**GOVERNMENT OF THE DISTRICT OF COLUMBIA
DEPARTMENT OF TRANSPORTATION**

MEMORANDUM

SUBJECT: ZC Case No. 16-24 – 1336 8th Street NW

Figure 1: Site Design and Access (Source: Gorove/Slade, CTR dated April 10, 2017, Figure 7)

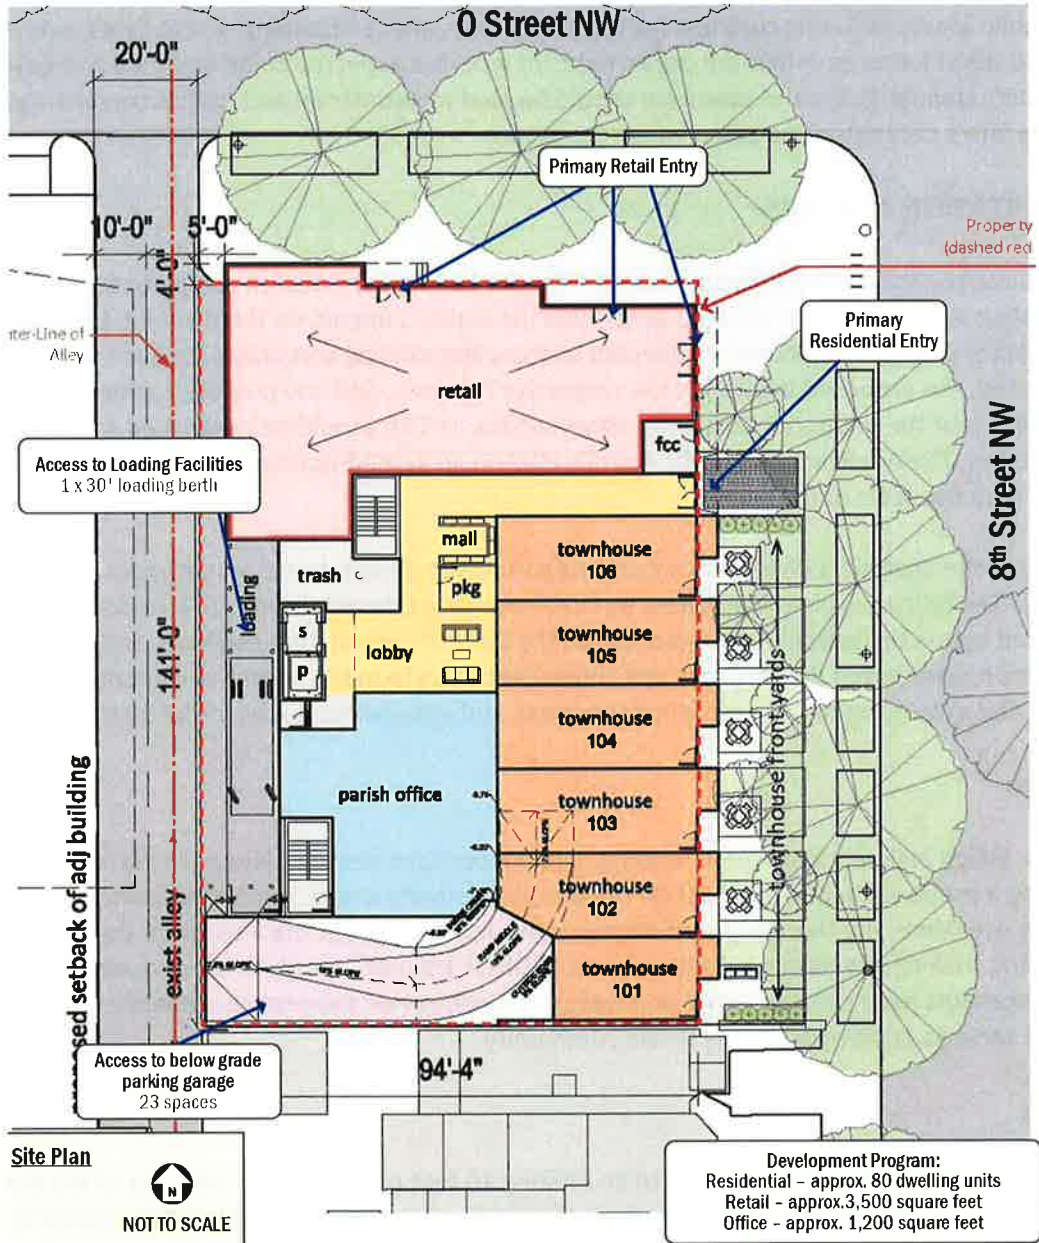
The proposed project is located adjacent to an existing 10 foot public alley to the west of the site and proposes to set back the building by 5 feet from the public alley. The approved PUD for 810 O Street NW (ZC Case No. 16-07), on the opposite side of the public alley, proposed to widen the curb cut for the public alley by 10 feet to 20 feet and set back their building along the eastern boundary by 10 feet. While neither setbacks of the two buildings are granting public easements, the setback effectively widens a portion of the alley to 25 feet, with a 20 foot curb cut. Vehicular, loading, and bicycle access is proposed via this public alley. All truck maneuvering associated with this proposed project could feasibly take place in the existing 10 foot alley and 5 foot setback once trucks pass the curb cut for the public alley without using the 10 foot setback of the 810 O Street NW development. However, a 20 foot curb cut to the public alley is necessary to enable truck turning maneuvers. The 810 O Street NW project is currently in litigation, and the timeframe for construction is uncertain. Therefore, whichever of the

two PUDs that completes construction first should widen the northern curb cut to the public alley to 20 feet.

The Applicant proposes 27 long-term bicycle parking spaces, which meets the zoning requirement of 27 spaces. The Applicant proposes short-term bicycle parking spaces, but did not specify the amount. However, eight spaces (4 racks) are shown on the site plan submitted as part of the CTR (see Figure 1). Zoning requires a minimum of 6 short-term bicycle parking spaces (3 inverted-U racks); the location will be worked out during the public space permitting process.

Figure 6: Existing Pedestrian Infrastructure (Source: Gorove/Slade, CTR dated April 10, 2017, Figure 20)

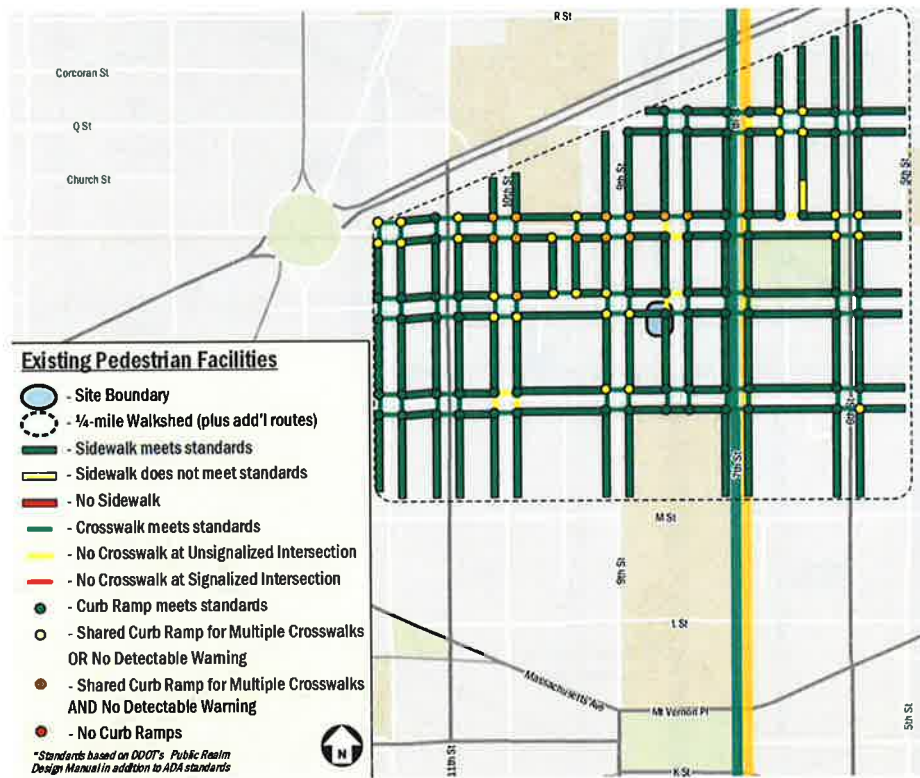
The Applicant performed an inventory of the pedestrian infrastructure in the vicinity. While the Applicant shows that not all of the existing pedestrian facilities within one-quarter mile of the site meet DDOT standards, curb ramps will be upgraded as a part of the build-out for ZC Case No. 16-07 and the north crosswalk at the intersection of 8th Street and O Street is appropriate since it is a curb less street with raised crosswalk.
